Preclosure Seismic Design Methodology and Performance Demonstration

*NRC/DOE Technical Exchange and Management Meeting
June 7, 2006*

**NRC Interim Staff Guidance,
Draft HLWRS-ISG-01,
*Review Methodology for Seismically
Initiated Event Sequences***

Figure not to scale

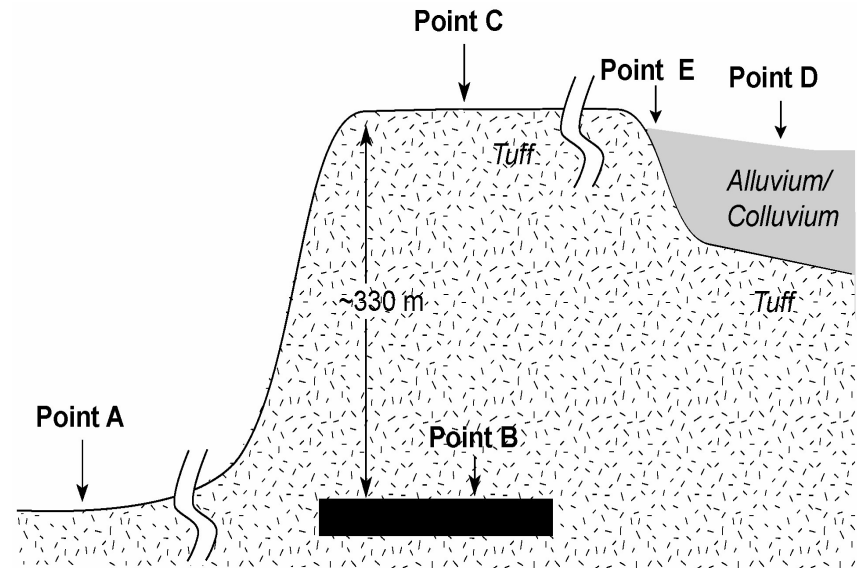
- YM PSHA (CRWMS M&O, 1998) provided hazard curves for Point A
- Site response modeling needed to obtain site specific hazard curves for points D, E, and B

- DOE provided site specific response spectra at annual probabilities of exceedance of 10^{-3} , 5×10^{-4} , and 10^{-4} (Points D and E)
 - One-dimensional equivalent-linear modeling (Bechtel SAIC Company, LLC, 2004, MDL-MGR-GS-000003)
 - Site specific geotechnical data (Bechtel SAIC Company, LLC, 2002, ANL-MGR-GE-000003) for a portion of the Surface Facilities Area

- Site response modeling considerations:
 - 2D and/or 3D site effects
 - Nonlinear site-response model
 - Appropriate site geotechnical data
- Development of an appropriate site specific hazard curve
 - Incorporation of recent site response modeling results
 - Appropriate annual probabilities of exceedance
